SPECIALIST STUDY: NOISE IMPACT ASSESSMENT: PROPOSED GREAT KAROO WIND ENERGY FACILITY NEAR SUTHERLAND: CHANGE OF WIND TURBINE SPECIFICATIONS

The above-mentioned issue as well as report ACED-HV/NIS/201202-Rev 0 is of relevance.

Figure 1: Noise emission levels of various wind turbines

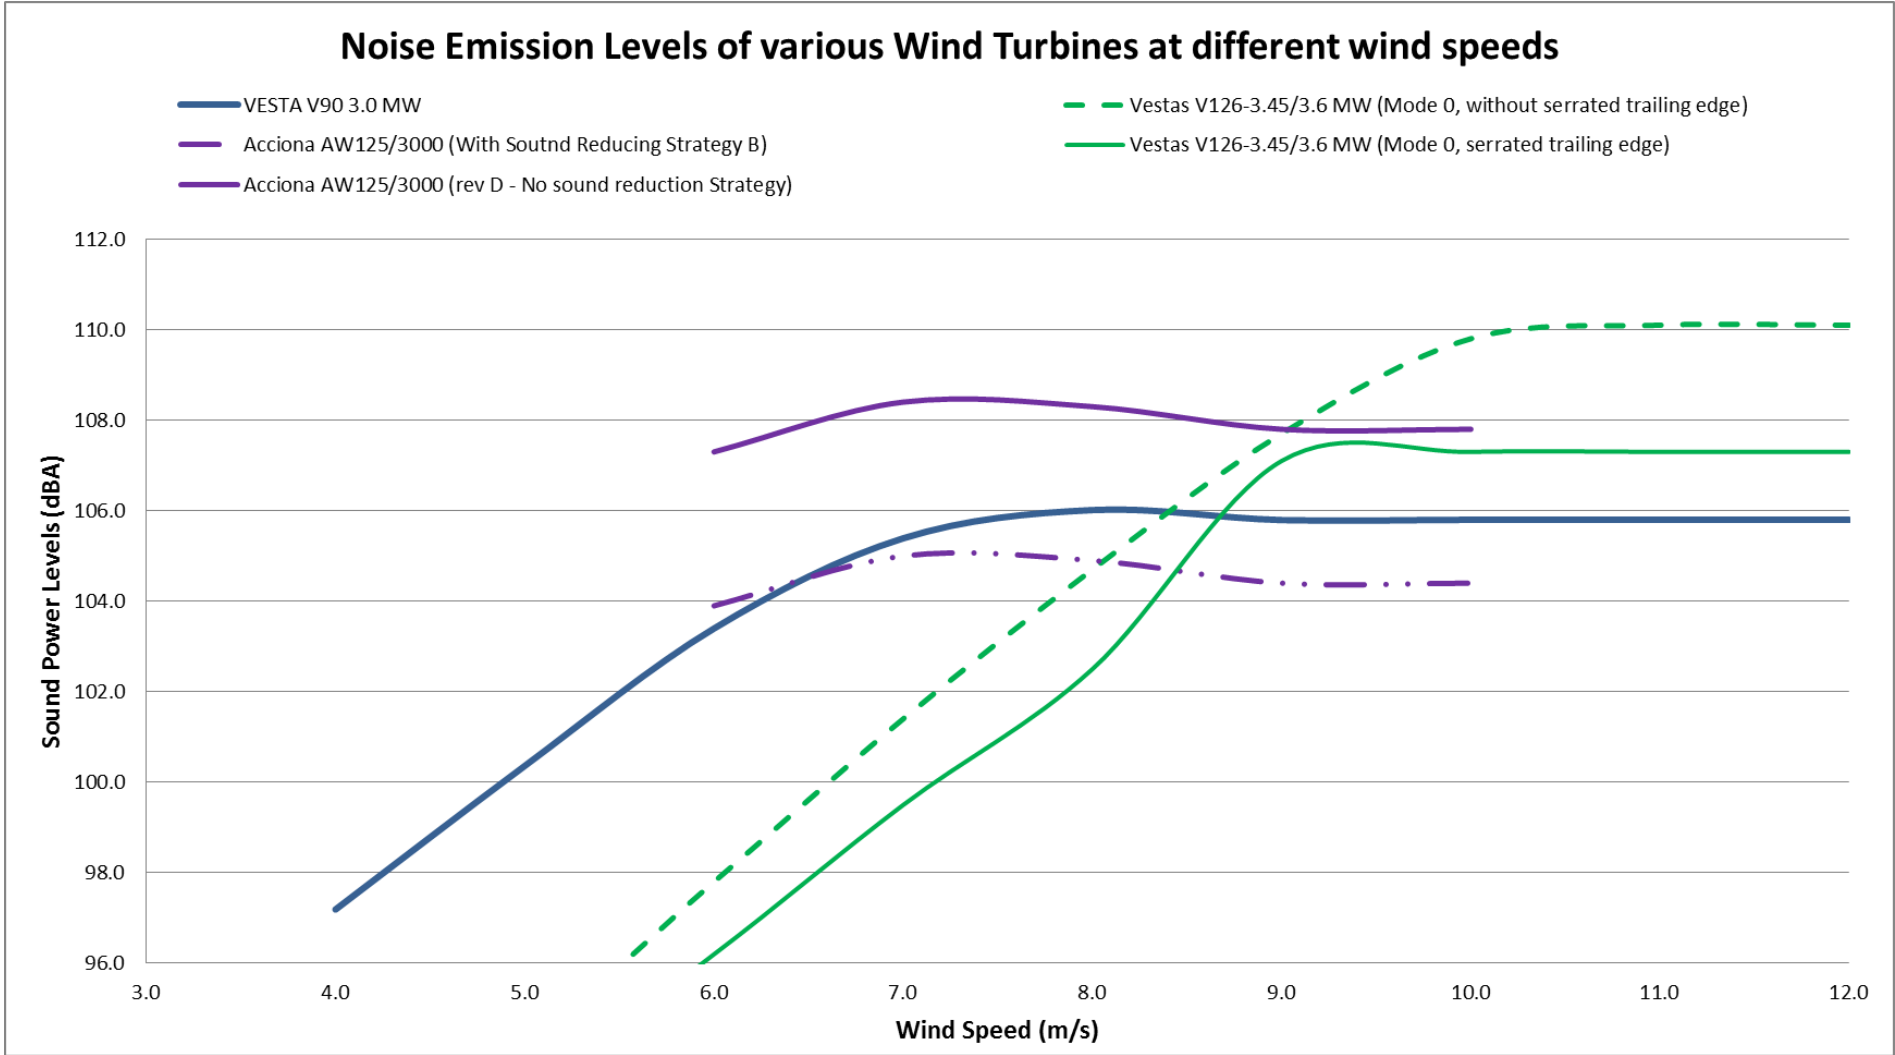
These turbines are louder than the Vestas V90 3.0MW wind turbine with about 1 – 2 dB, but noise emissions from these wind turbines can be managed by means of different operational modes, as well as the use of blades with the optional serrated trailing edge. The sound power emission levels of the Vestas V126 turbine with the two different blades are illustrated in **Figure 1** (similarly, the operating modes of the Acciona turbine). It is recommended that the turbine with such noise management option be used at locations closer than 1,200m from NSD07.

Considering the location of the wind turbines and the potential noise impact, it is my opinion that the change will not increase the significance of the noise impact. A full noise impact assessment with new modeling will not be required and the recommendations as contained in the previous document will still be valid.
